PLANT NAME: Surry 1 & 2

Serial No. 211
FR/JTR:agg

Docket Nos. 50-280
50-281

CHANGES TO LIMITING VALUES OF POWER
DISTRIBUTION PARAMETERS FOR CYCLE 3 OPERATION OF
SURRY UNITS NO. 1 AND 2 AS THE RESULT OF HIGHER UPPER HEAD
FLUID TEMPERATURES AND THIMBLE CELL ROD BOW EFFECT

Figure 1

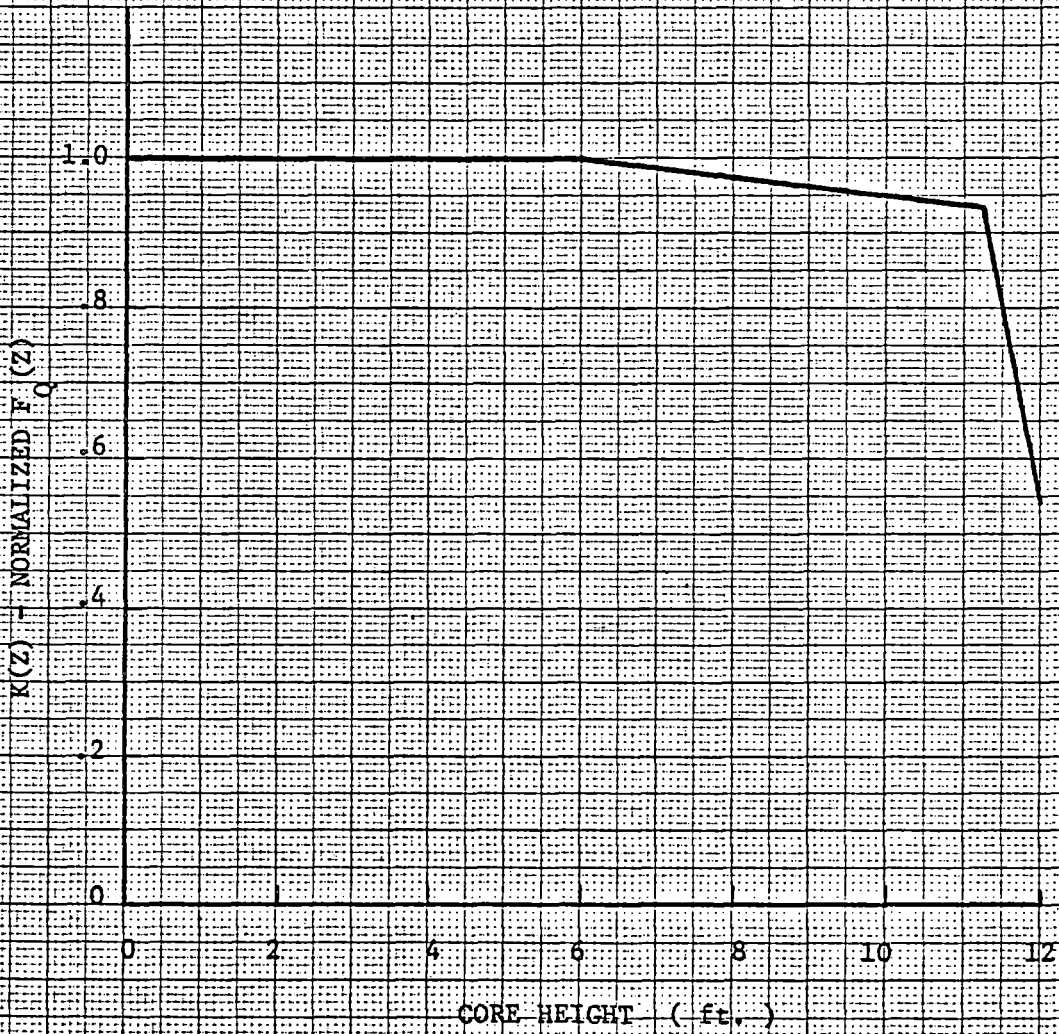
$$F_Q(Z) \leq (1.80/P) \times K(Z) \text{ for } P > 0.5$$

$$F_Q(Z) \leq (3.60) \times K(Z) \text{ for } P \leq 0.5$$

$$F_Q(Z) \leq (1.82/P) \times K(Z) \text{ for } P > 0.5$$

$$F_Q(Z) \leq (3.64) \times K(Z) \text{ for } P \leq 0.5$$

where P is the fraction of rated power at which the core is operating, K(Z) is the function given in Figure 1, and Z is the core height location of $F_Q(Z)$. Additionally, the limiting behavior of $F_Q(Z)$ for nominal transient operation of each unit shall be periodically evaluated. If this evaluation shows that $F_Q(Z)$ could potentially violate its limiting values either:

FIGURE 2

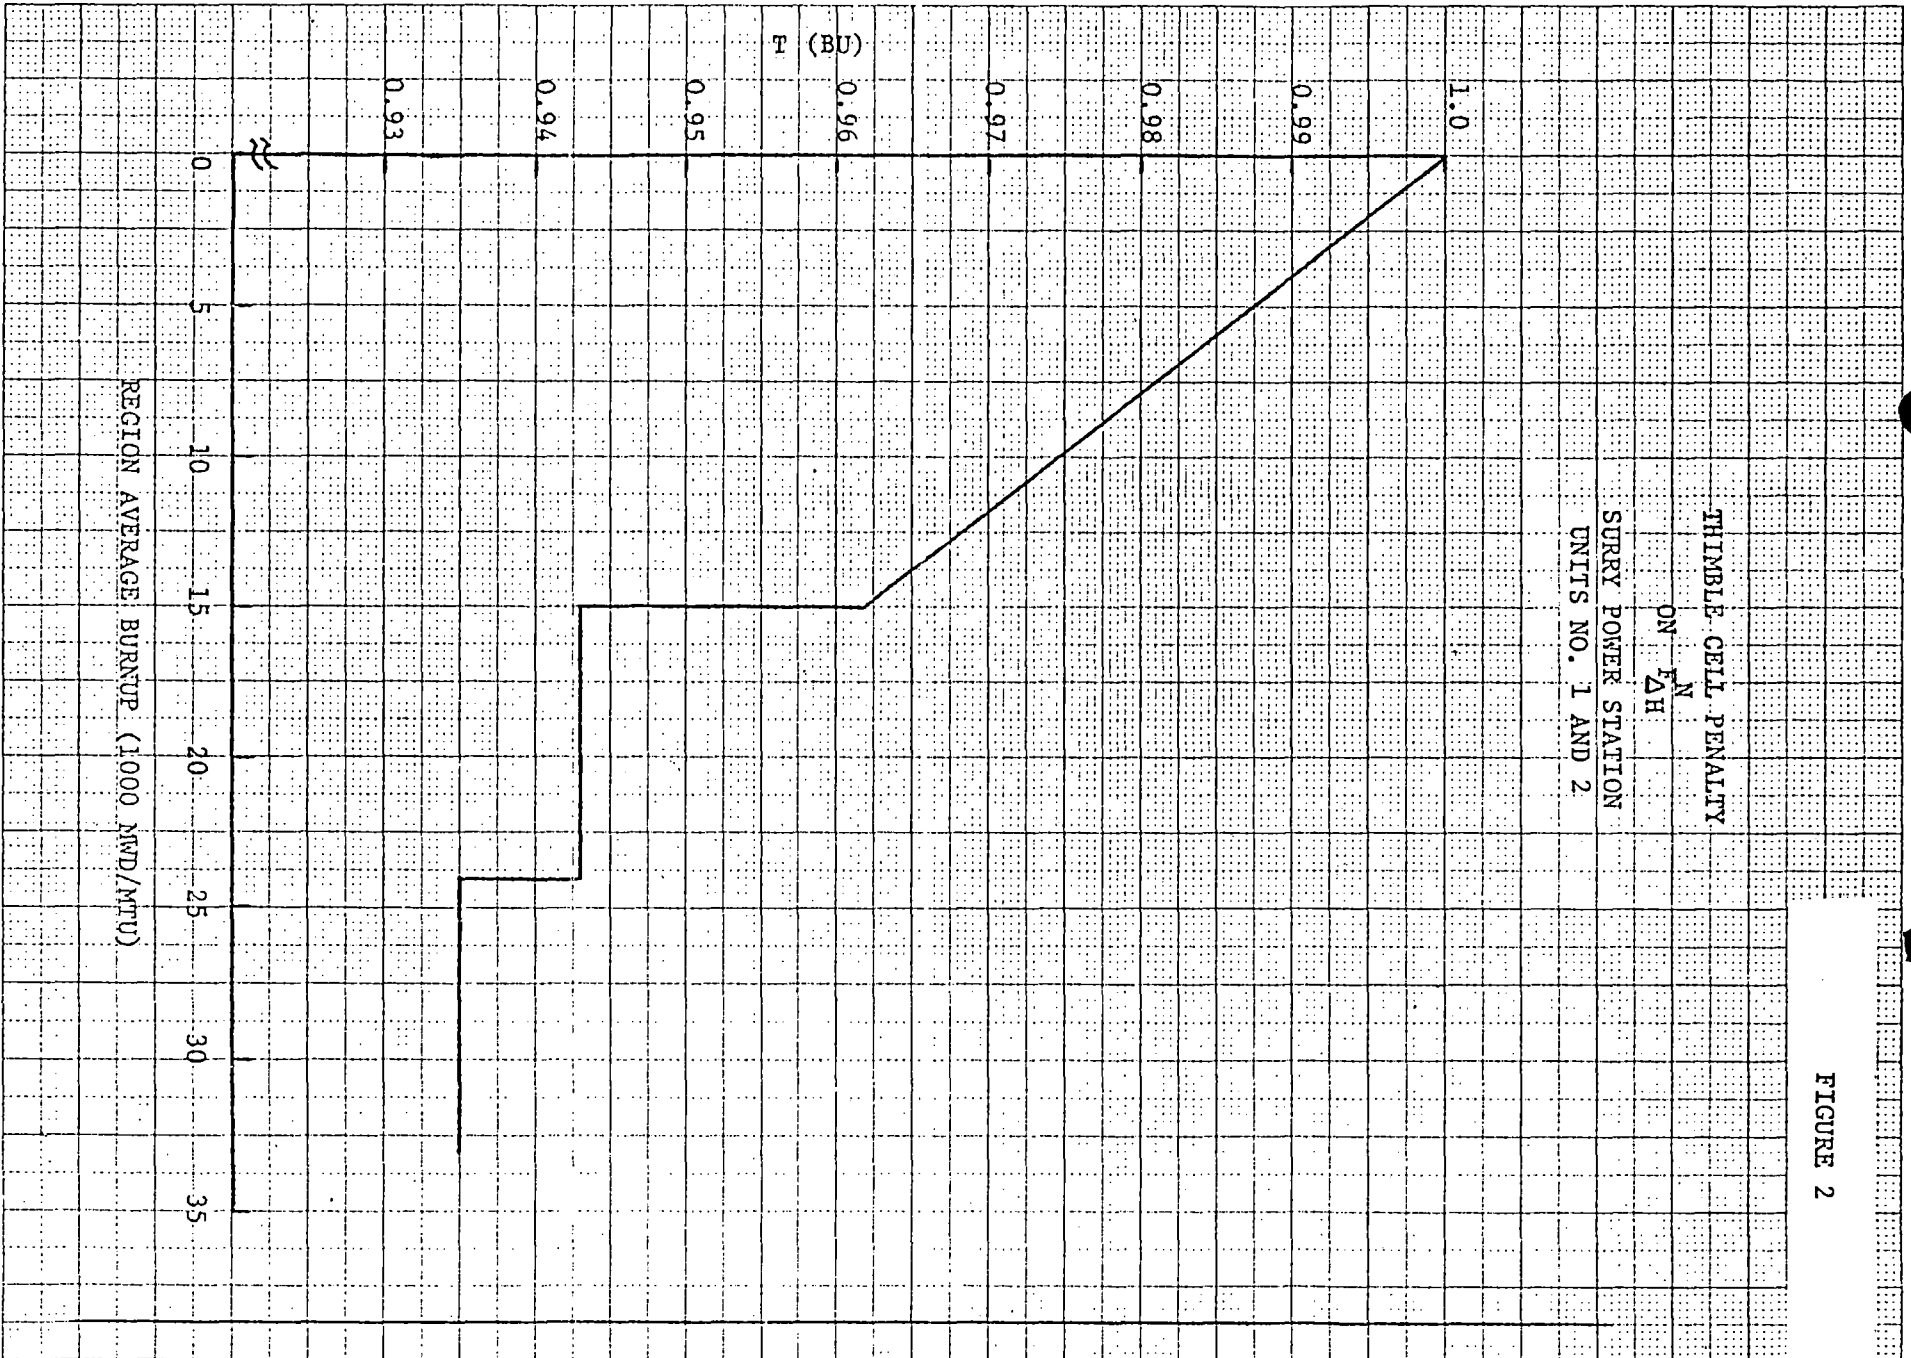
$$F_{\Delta H}^N = 1.55 \{ 1 + 0.2(1-P) \} \times T(\text{BU})$$

where P is the fraction of rated power at which the core is operating and T(BU) is the thimble cell penalty on $F_{\Delta H}^N$, which is given in Figure 2.
